December 15, 2021

Re: Comments regarding Picayune Strand Restoration Project Southwest Protection Feature Conveyance Features (File No. 0288313-013) permit modification.

Figure 1. Picayune Strand Restoration Project annual inflow and outflow discharge volumes for the AltPC2 condition. Discharges based on the Gridded Surface Subsurface Hydrologic Analysis (GSSHA) model provided by USACE.

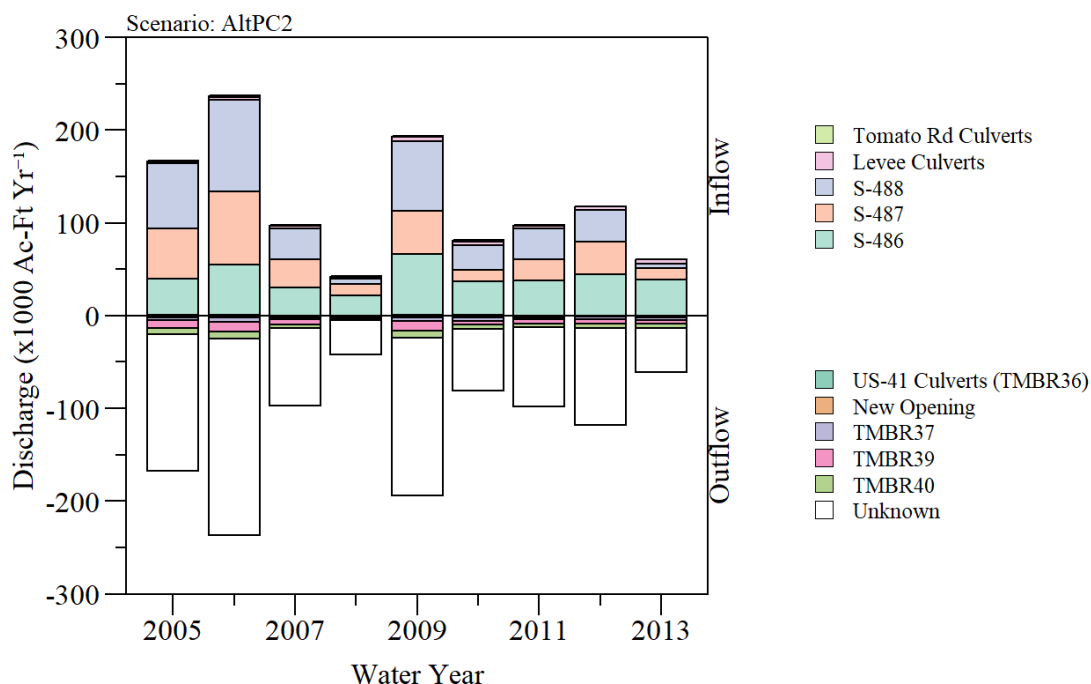
The “Picayune Strand Restoration Project (PSRP) Water Quality Projections With “Western Protective Levee” Feature” report (SFWMD 2020) prepared by the South Florida Water Management District (SFWMD or District) to support the U.S. Army Corps of Engineers permit application provides an analysis of flow distribution, quantifies the discharge and nutrient load associated with the Southwest Protection Feature (SWPF). The different modeled scenarios include phased implementation of the infrastructure associated with the SWPF project including a levee, the “New Out” structure and the completely restored PSRP. The analysis uses the direct proportionality principle to allocate discharge across the selected structures in the project area. However, an assumption of the direct proportionality principle states that all sources must be accounted for. As outlined in the Districts report, the “PSRP Existing Inflow” calculation is based on the difference in discharge from the structures along US-41 (outflow) and discharge through Levee Culverts and TAMTOM (Inflow). Based on this method, the estimated “PSRP Existing Inflow” volume has a high degree of uncertainty and inaccurately represent actual existing flow conditions given that all outflow (i.e. discharges to the east via US41 Canal and/or discharges from other drainages along US41) are not quantified in the analysis. In the AltPC2 (restored) condition approximately 80% of the outflow discharges are not accounted for in the basic water balance represented below (Figure 1; assuming that rainfall inputs equal evapotranspiration outputs). Moreover, in the SWPF+ condition (i.e. Levee and New Opening) the water balance is still not closed since other discharges are not represented.

Figure 2. Average hydroperiod across the simulated period during the FWO, AltPC2, SWPF, and SWPF+ condition within the Picayune Strand Restoration Project in the vicinity of the Southwestern Protection Feature.

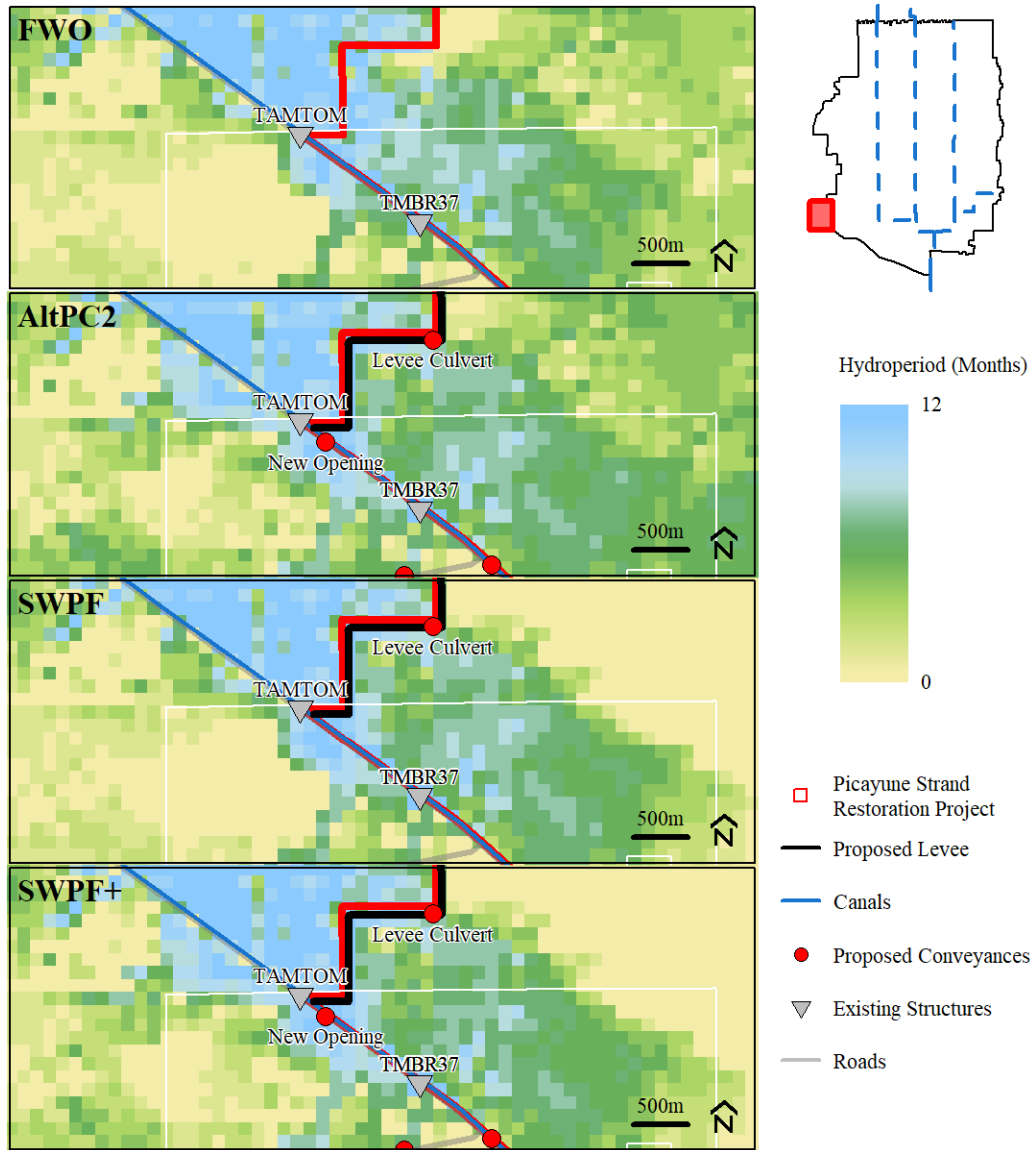
The AltPC2 condition assumes that restoration water will “dilute” existing water quality concentrations sufficiently to reduce potential impacts associated with high nutrient water entering the downstream Outstanding Florida Waters (OFWs). However, a comparison of the provided average hydroperiod maps

(and difference comparisons), recreated below (Figure 2) indicates very little change in the immediate area of the SWPF across the different scenarios. Moreover, the hydroperiod maps highlight the potential impact of the SWPF and “Levee Culvert” by reducing hydroperiods in some areas (east of proposed levee) and increasing in others (slough downstream of Levee Culverts).

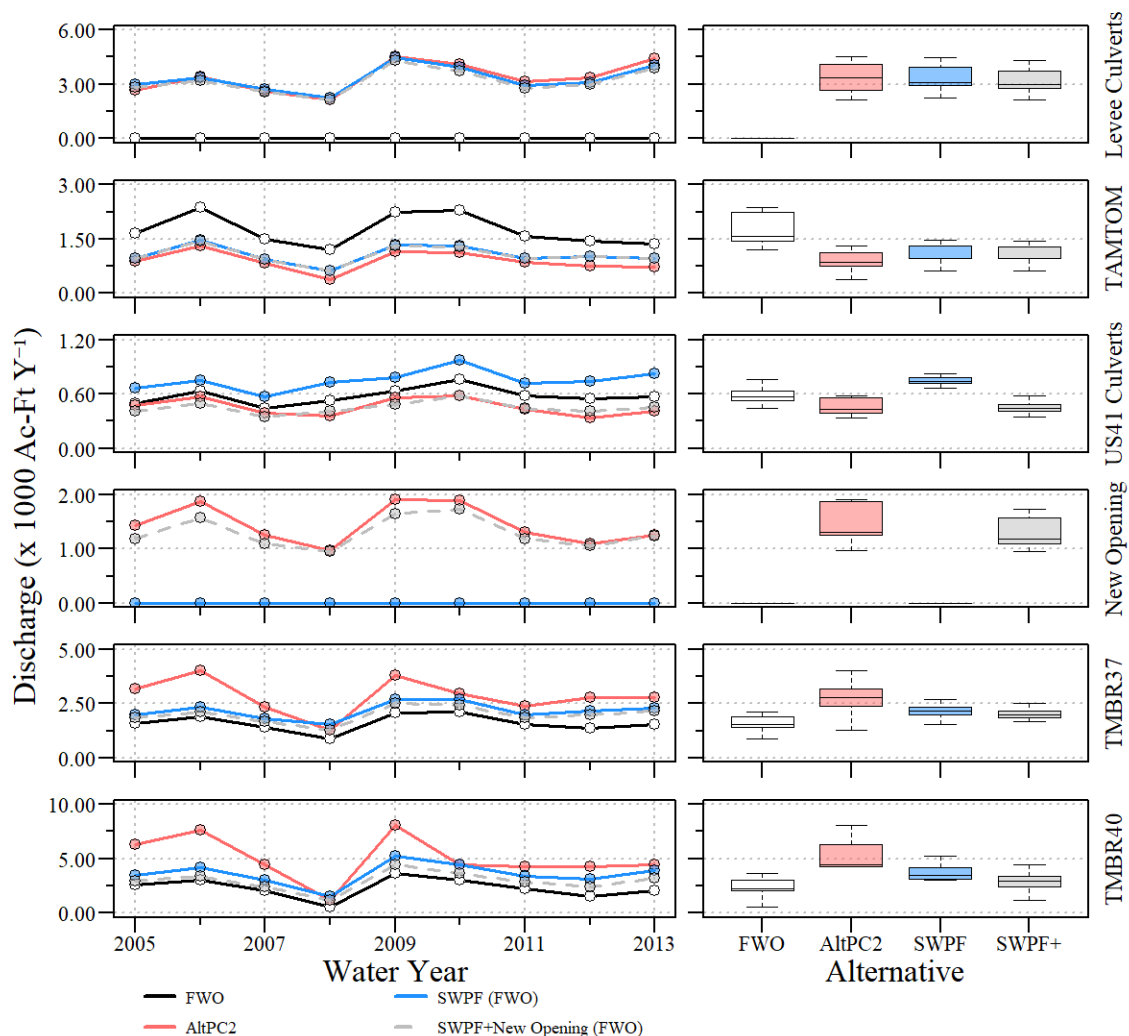
Across the project area at downstream locations along the US-41 canal, discharge volumes vary between the AltPC2 and SWPF+ alternatives (Fig 3). Discharges through Levee Culvert do not deviate much between AltPC2 and SWPF+ alternatives with an average percent change of 7%, which could be attributed to increased seepage in the AltPC2 condition. Based on the comparison of annual discharge volume at US-41 Culverts and New Opening between AltPC2 and SWPF+ alternatives, the amount of discharge attributed

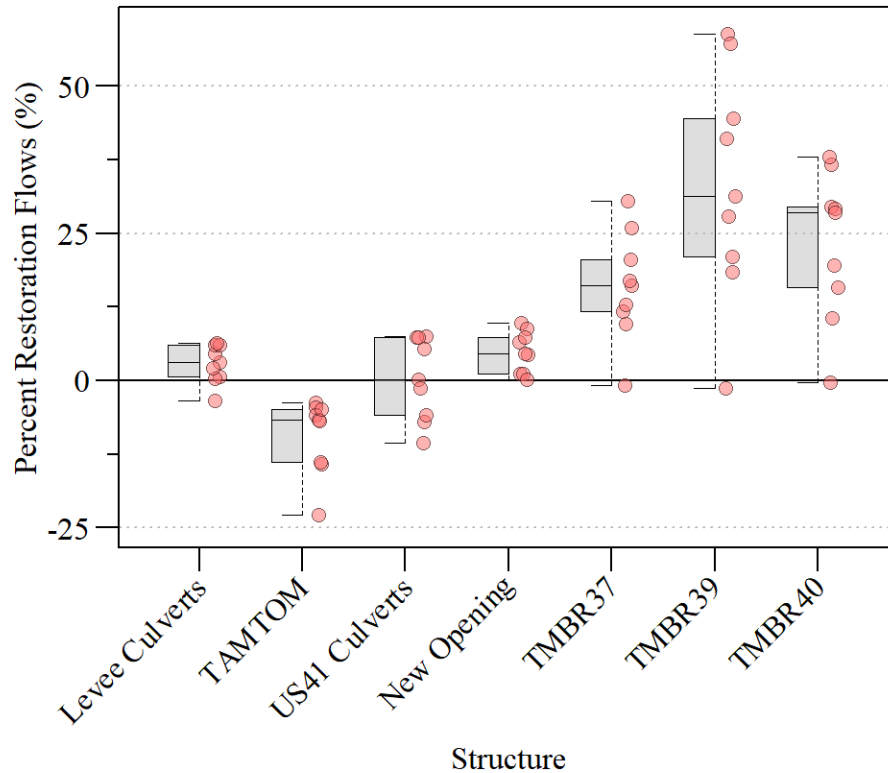
to restoration flows is minimal. For New Opening, percent restoration flows range from 0.1% to 9.8% while US-41 Culverts range from -10.6% to 7.6% suggesting that in some years discharge in the SWPF+ scenarios are greater than that of AltPC2 (Figure 4). Moreover, percent restoration flows gradually increase moving west to east with TMBR39 experiencing the greatest average percent restoration flows (33.2%; Figure 4). These results suggest that even during the fully realized restoration of PSRP, restoration flows have a very small contribution to the overall discharge of the US-41 Culverts in the immediate area of the SWPF including the New Opening therefore the presumed dilution of existing water quality may not be sufficient to ensure acceptable water quality conditions.

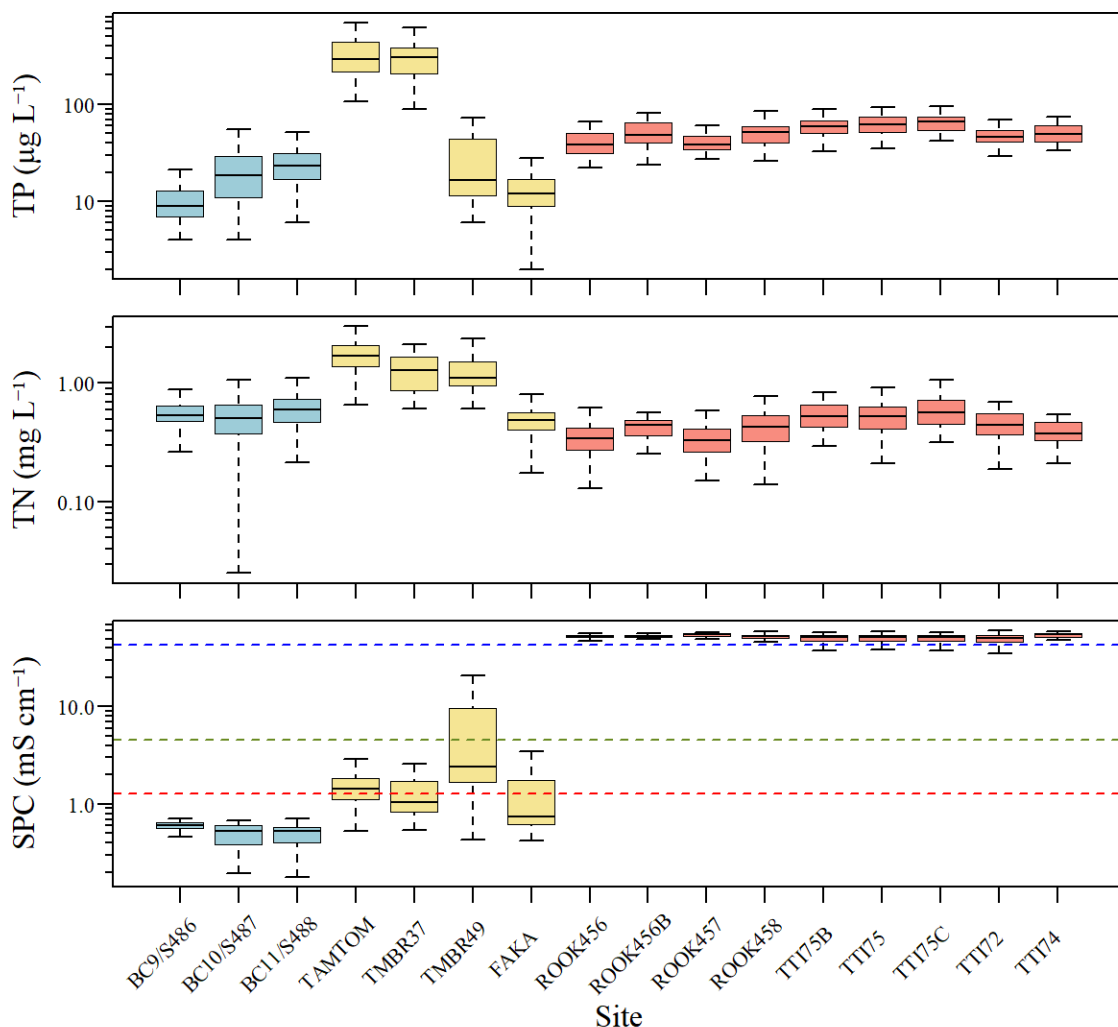
To quantify the potential changes to water quality concentration and loads across the different alternatives the District used existing data to be representative of agricultural, existing and restored flows. Data from monitoring locations TAMTOM and TMBR37 were used to represent agricultural flow water quality. Meanwhile, TMBR49 and FAKA were used to represent both existing and restored flows. While the water quality at TAMTOM can justifiably be assumed to be from agricultural sources (High TP and TN; Figure 4), the water quality at TMBR37 is a mixture of flows from TAMTOM and that of existing run-off from PSRP. Moreover, at its essence water quality at FAKA is a mix of sources including shallow groundwater, estuarine waters, and possibly contributions by nearby residential areas (i.e. Port of the Isles) and less indicative of restored conditions but rather existing impacted drainage conditions.

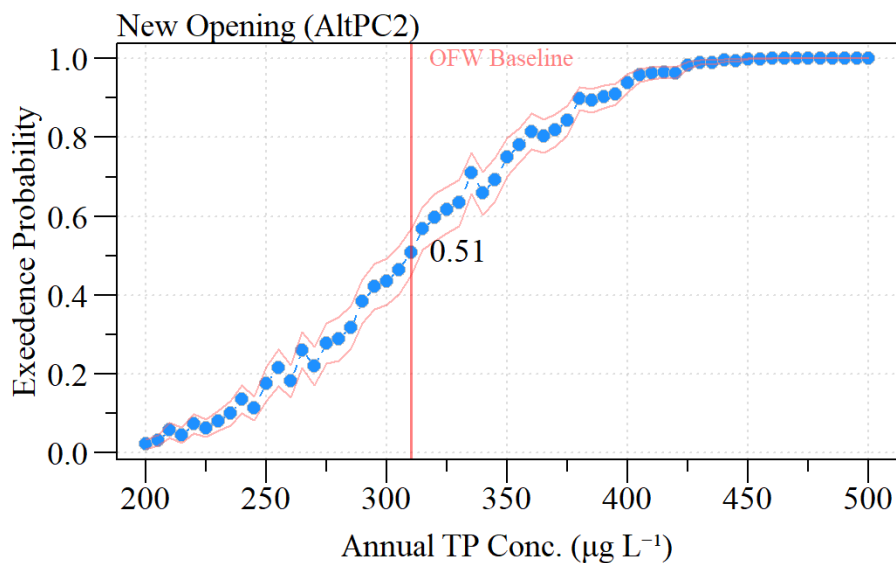
Regardless of fundamental flaws in the water quality analysis and partitioning of flows, the Districts analysis projects this project will add an average $552 \pm 125 \text{ kg P}$ (mean \pm standard deviation) and $2,733 \pm 559 \text{ kg N}$ (SFWMD 2020) via the “New Opening” (i.e. culverts under US41) into Collier Seminole State Park, an OFW. The Districts analysis (SFWMD 2020) concluded that water quality under the AltPC2 will be lower than the established OFW baseline concentrations based on long-term flow-weighted mean

concentration despite an annual TP exceedance rate of 44% (4 exceedances out of 9 modeled years). This analysis assumes that a flow-weight mean to geometric mean concentration (OFW baseline values estimated as geometric mean concentration) conversion was one-to-one, however, based on prior work (i.e. Restoration Strategies, Technical Oversight Committee Appendix A Subteam, Western Everglades Restoration Planning Project) these conversion values can vary dramatically. Even a small deviation (~2%) from the current 1:1 conversion factor could result in long-term average concentrations above that of baseline concentration (for TP). Furthermore, a Monte Carlo Analysis similar to the one used in the estuarine numeric nutrient criteria development (FDEP 2012), was used to evaluate the modeled data for the New Opening structure under the AltPC2 alternative presented by the District. Given the variability of the data, this analysis demonstrates that water quality at the New Opening structure has a probability of exceeding the TP OFW baseline concentration of 310 $\mu\text{g/L}$ approximately 50% of the time (Figure 6). Given this exceedance probability, discharges through the New Opening (i.e. waters being discharged into CSSP, an OFW) will most likely exceed the OFW baseline concentration thereby degrading the OFW condition and potentially impacting flora and fauna.
